Access Compliance Report Public Rights-of-Way (Curb Ramps)

Main Street: SIENNA_PKWY		Cross Street: N_SELLAS_RD		Location:	N
ADA ID: RPRK211109125446	Ramp Type: Type 1 - Perpendicular	Initial Pass/Fail: Pass	Overall Compliance: No	Severity Score:	15

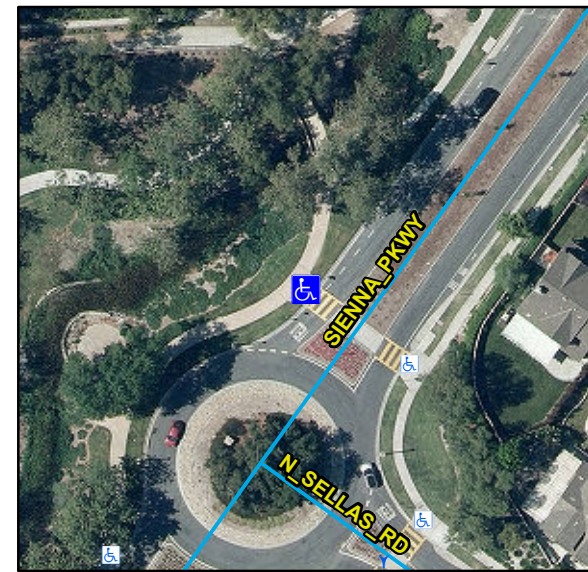
Compliance	Description	Data	Compliance	Description	Data
N/A	Ramp Length (in)	88	N/A	Flare Type LT	
Yes	Ramp Width (in)	48			Sloped
Yes	Ramp Run Slope (%)	8.2	N/A	Flare Slope LT (%)	6.6
Yes	Ramp Cross Slope (%)	0.2	N/A	Flare Traversable LT	No
N/A	Landing Present	Yes	N/A	Flare Type RT	
N/A	Landing Length (in)	96			Sloped
Yes	Landing Width (in)	48	N/A	Flare Slope RT (%)	10.2
No	Landing Run Slope (%)	2.1	N/A	Flare Traversable RT	No
Yes	Landing Cross Slope (%)	0.7	No	DWS Provided	No
N/A	Landing Movement Obstructed?	No	N/A	DWS Contrast	N/A
	Landing Movement Type	N/A	N/A	DWS Length (in)	N/A
N/A	Landing Shared	No	N/A	DWS Full Width	N/A
N/A	Clear Space	N/A	N/A	DWS Offset Left (in)	N/A
N/A	Clear Space To Crosswalk (in)	N/A	N/A	DWS Offset Right (in)	N/A
N/A	Marked Crosswalk 1	Yes	N/A	Marked Crosswalk 2	N/A
	Crossing 1 Direction	SE		Crossing 2 Direction	N/A
	Marked Crosswalk 1 Width (in)	144		Marked Crosswalk 2 Width (in)	N/A

Yes	Ramp Inside Crosswalk 1	Yes	Yes	Ramp Inside Crosswalk 2	N/A
	Crossing 1 Slope (%)	1.4		Crossing 2 Slope (%)	N/A
	Crossing 1 Cross Slope (%)	1.1		Crossing 2 Cross Slope (%)	N/A
Yes	Gutter Ponding	No	No	Curb Slope	6.2
Yes	Gutter Lip Height (in)	0		Road Run Slope (%)	N/A
No	Gutter Run Slope (%)	10.1		Road Cross Slope (%)	N/A
No	Gutter Cross Slope (%)	2.5			
Yes	Overall Surface Condition: Acceptable		No	Perp Joint Present	No
	Cross Gutter Present?	No		Spandrel Present?	No
	Replace Cross Gutter?	N/A		Replace Spandrel?	N/A

Remove & Replace Entire Ramp. Remove & Replace Gutter.
